# Proposed Cudgera Creek Caravan Park

Review of Effluent Management Plan

P2410460JR01V01

Prepared for Tweed Shire Council

**Figure 1:** SEPP (Resilience and Hazards) mapping.

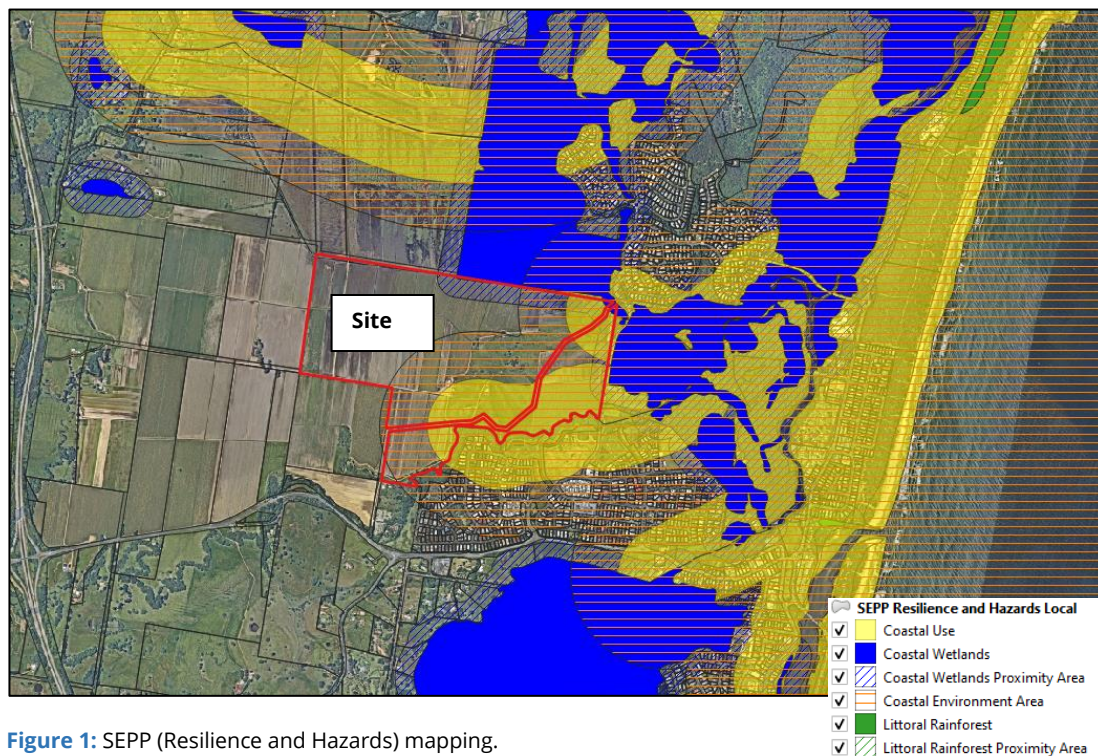
Planning Instrument / Development Control	Relevant Clauses / Sections	Assessment
State Environmental Planning Policy (Resilience and Hazards) (2021)	2.7 Development on land within coastal wetlands  2.8 Development on land in proximity to coastal wetlands.	Site contains mapped coastal wetlands, coastal wetlands proximity area, coastal environment area and coastal use area (Figure 1).

Planning Instrument / Development Control	Relevant Clauses / Sections	Assessment
	<p>2.10 Development on land within coastal environment area</p> <p>2.11 Development on land within coastal use area</p>	<ul style="list-style-type: none"> <li>• Clause 2.7 – Not relevant. No onsite wastewater infrastructure proposed in mapped wetland..<sup>1</sup></li> <li>• Clause 2.8 – Not relevant. No onsite wastewater infrastructure proposed in mapped wetland proximity area..<sup>2</sup></li> <li>• Clause 2.10 – Onsite effluent irrigation area and sewage management within mapped Coastal Environment Area. Insufficient information provided to demonstrate proposed systems will not adversely impact on the integrity and resilience of the biophysical, hydrological (surface and groundwater) and ecological environment..<sup>3</sup></li> <li>• Clause 2.11 – Wet weather storage lagoon within mapped Coastal Use Area. Insufficient information provided to demonstrate proposed development will not adversely impact on visual amenity and is of an appropriate scale..<sup>4</sup></li> </ul>
